CERTIFICATE OF APPROPRIATENESS

Property: 8438 Glen Valley Dr, Lot 4, Block 20, Glenbrook Valley Subdivision. The property includes a historic 1,800 square foot, one-story single-family residence situated on a 7,700 square foot (70' x 110') interior lot.

Proposal: Alteration – Windows/Doors

APPLICANT PHOTOS – EXISTING / PROPOSED WINDOWS

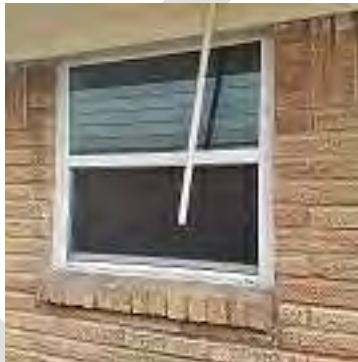
Staff is recommending approval for Windows 5, 6, 7, and 9; denial for Windows 1, 2, 3, 4, and 8.

SAMPLE COMPARISON – REMOVED WINDOWS / PROPOSED WINDOWS

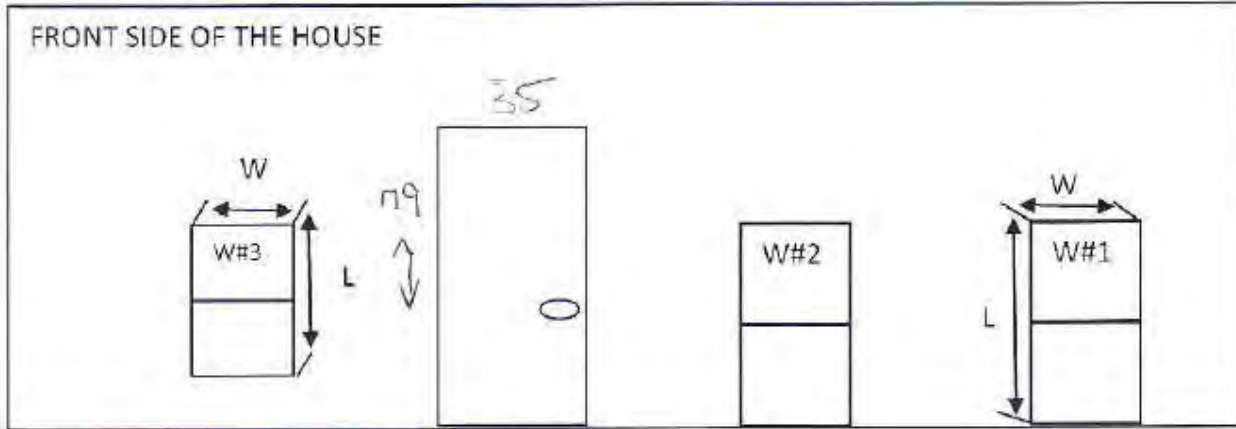
(a) The proposed activity must recognize the building, structure, object or site as a product of its own time and avoid alterations that seek to create an earlier or later appearance; and *Windows with interior grids are not typical of residences constructed ca. 1956 and create a later appearance for the building.*

(b) The proposed activity must match the architectural features, materials, and character of either the existing noncontributing structure or the contributing structures within the context area. *The proposed windows feature interior grids, which do not match the features of the removed windows or historic windows found on contributing structures.*

If the applicant were to install windows with exterior grids, or windows that feature a simplified 1/1 lite pattern, staff finds the proposal would satisfy criterion 1.
